ISSUE: Certificate of Appropriateness for signage and Waiver of Vision Clearance

APPLICANT: Mount Vernon Petroleum Realty, LLC

LOCATION: Old and Historic Alexandria District
703 North Washington Street

BAR #2019-00192
703 North Washington Street

Figure 3: signage now proposed for the Exxon station at 703 North Washington Street

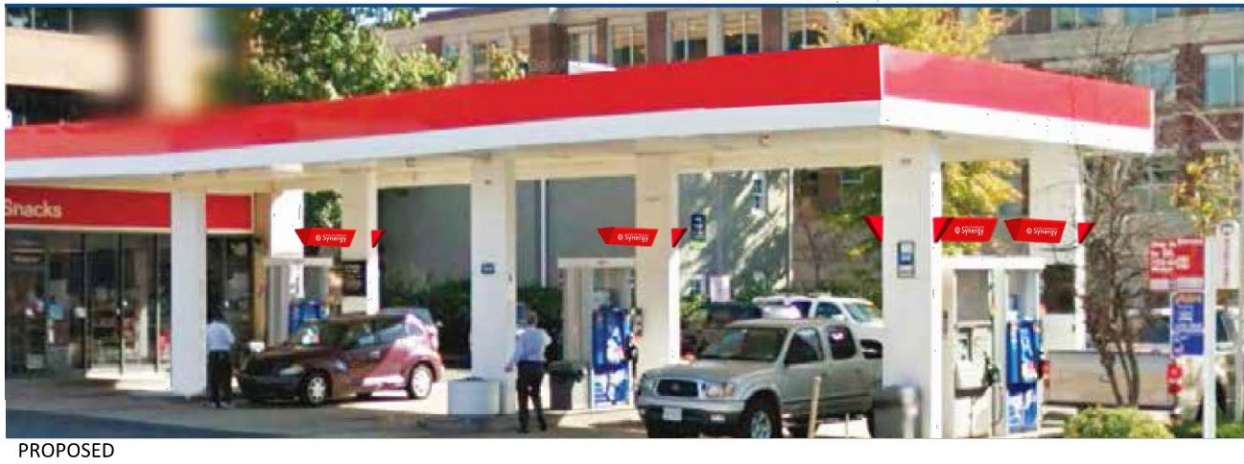
Staff finds the number of blade signs and wedge signs mounted on the canopy poles above the pumps to be acceptable since the applicant removed the signs' normal internal illumination proposed in the previous application and, significantly, has removed all of the Exxon signs from the face of the canopy above the pumps. Staff notes that all of the window signs were removed prior to submitting this application and that only the snacks and two wall-mounted signs describing state inspection requirements remain. Any future window or wall signs not included with this package would be subject to another sign permit submission and BAR review/approval.

Therefore, staff recommends approval of the proposed sign plan, with only the price numerals themselves on the monument sign internally illuminated, and with the intensity of the sign lighting to be reviewed by staff at night in the field to ensure the compatibility of the illumination with the surrounding streetscape as is the BAR's standard condition.

PROPOSED PRICE ID SIGN
MONUMENT SIGN DETAIL

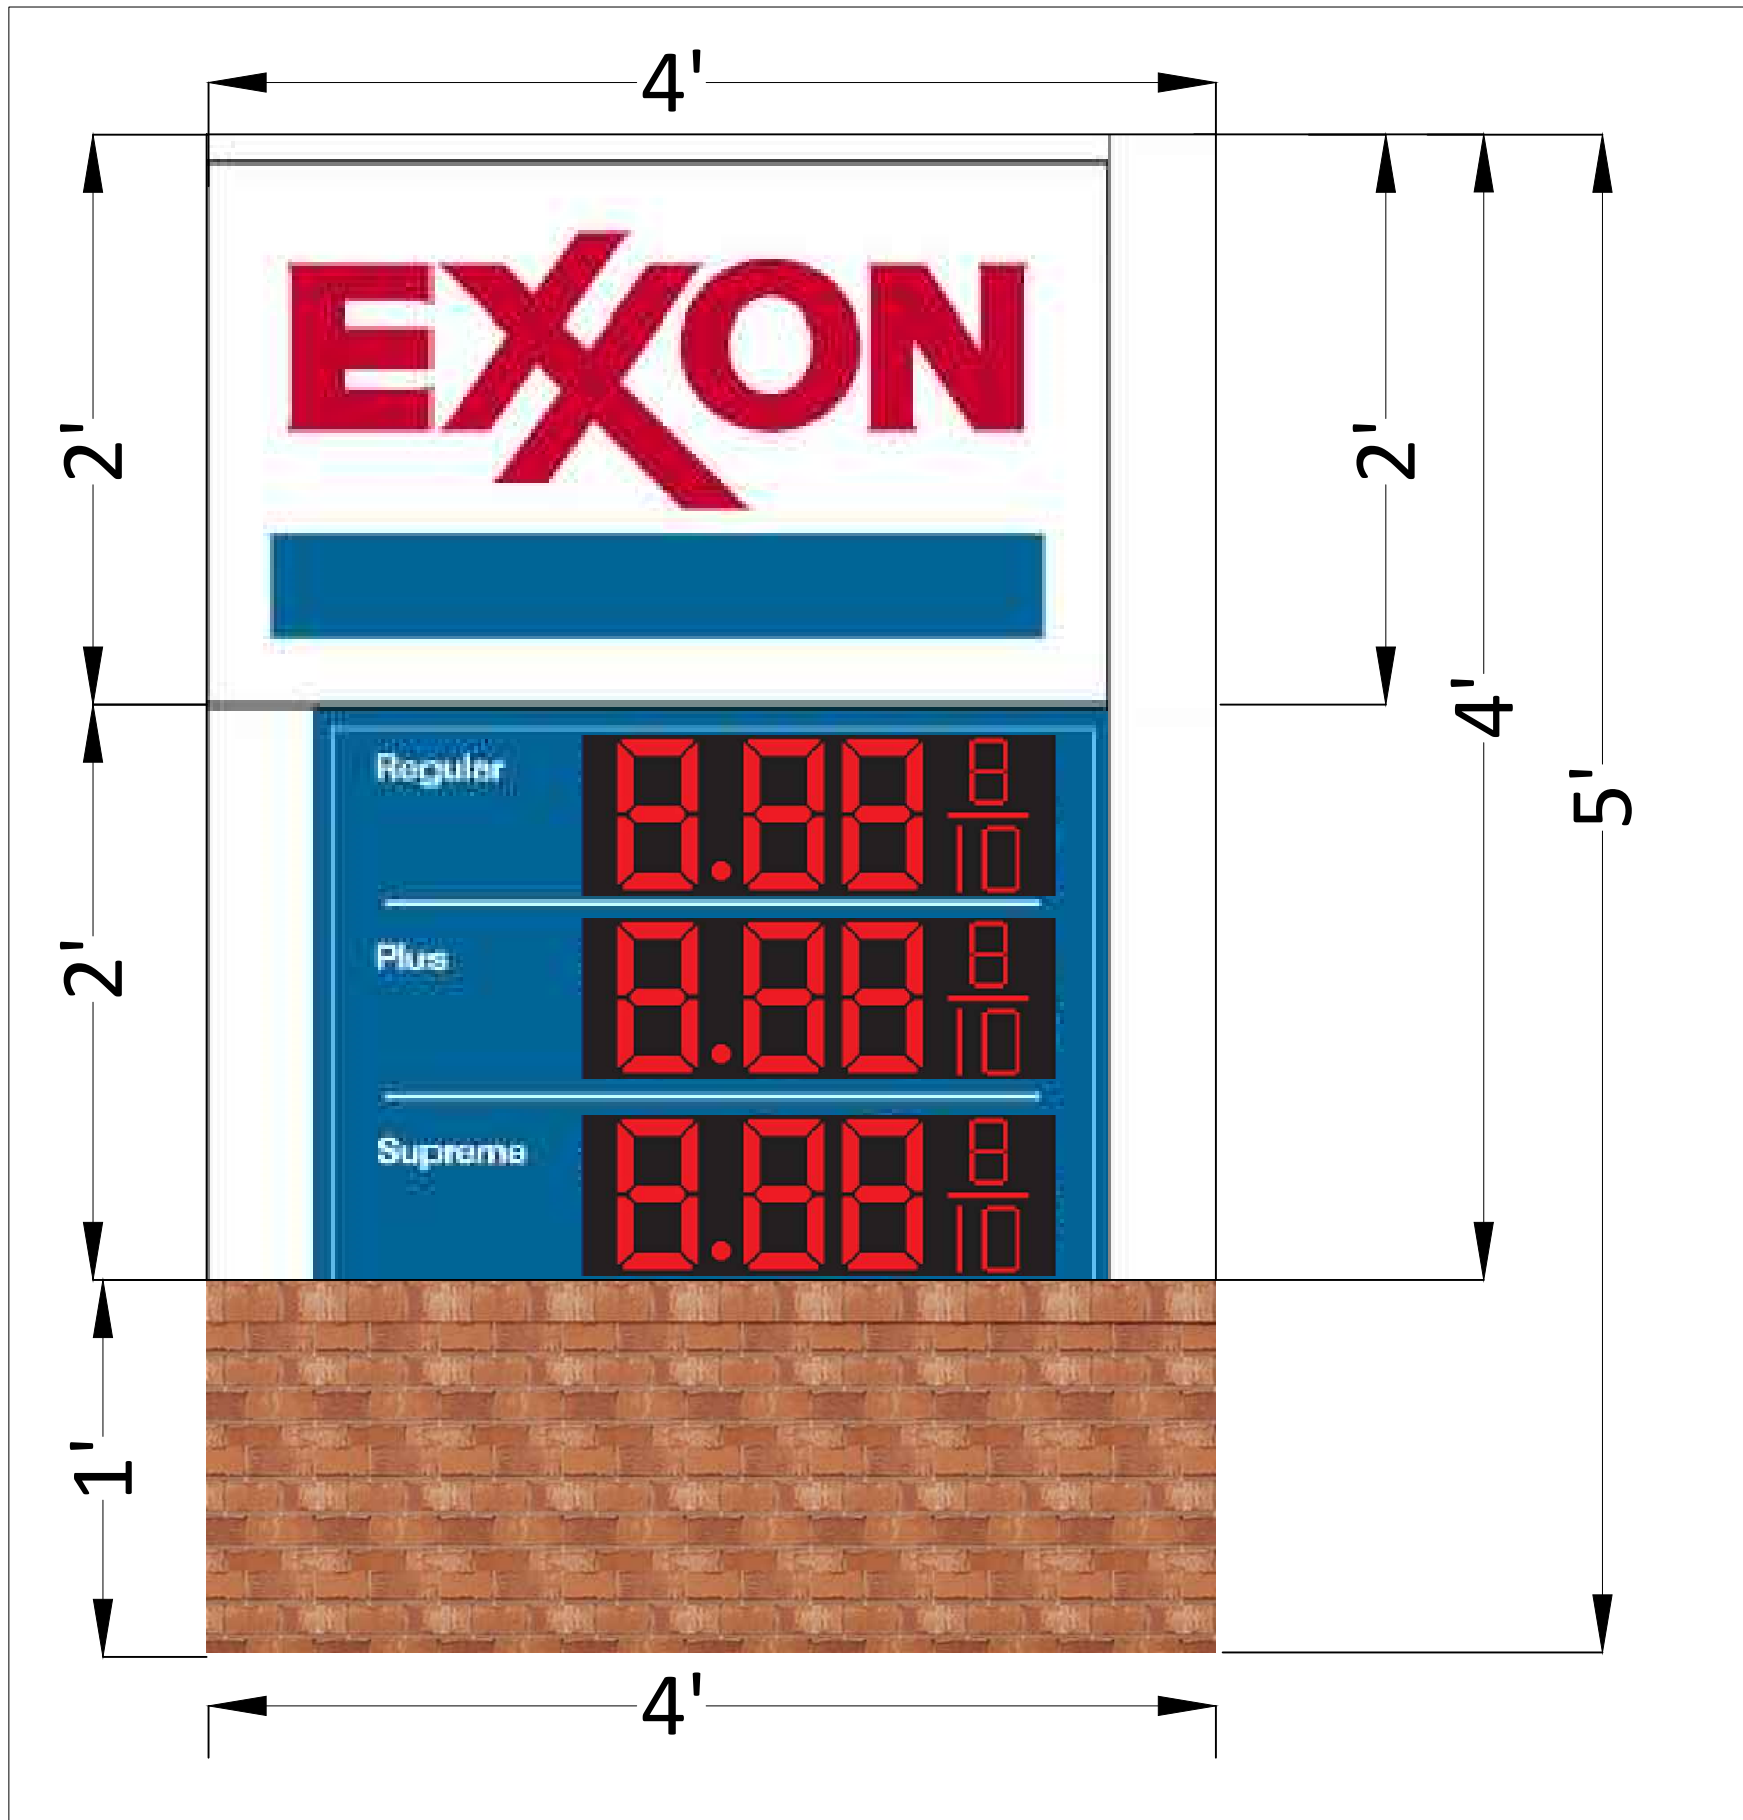
parkway.” However, the NPS still finds that the illumination “is not appropriate” and recommends that the applicant reconsider.

The price numbers are proposed to be LEDs, which is now the industry standard, and these have been installed on stations throughout Alexandria, including the Shell station that was approved several years ago by the PG BAR for 442 North Henry (Figure 1). Staff has not received any objections from the community about these lights. However, the present applicant has agreed to install dimmers on the LEDs and to work with staff in the field at night to reduce their intensity if they are found to be incompatible with the illumination levels of the surrounding streetscape on Washington Street, as is the BAR’s standard condition for lighting.

Section 7-800 of the Zoning Ordinance states that corner lots must provide vision clearance for safety of travel on streets that precludes "structure, fences, shrubbery or other obstruction to vision more than three and one-half feet above the curb level." Section 7-802 of the Zoning Ordinance gives the BAR the authority to waive the vision clearance requirement "where to do so would be consistent with the historic character of the district." Staff supports the proposed Vision Clearance Waiver and the maximum size permitted by the City Code for a price ID sign, on a one-foot tall masonry base.

- The site is located within the North Washington Street area from Bashford Lane to Pendleton Street. The proposal is for new signage at an existing petroleum station.
- The proposed price ID sign as we appreciate the scale of the sign being reduced significantly and the use of a brick base to provide continuity within the historical character of the parkway the illumination of the sign is not appropriate and we would ask you to reconsider the illumination.

1. No signs on the site may be internally illuminated except for the LED price numerals on the monument sign, whose intensity is to be reviewed by staff at night in the field to ensure the compatibility of the illumination with the surrounding streetscape.
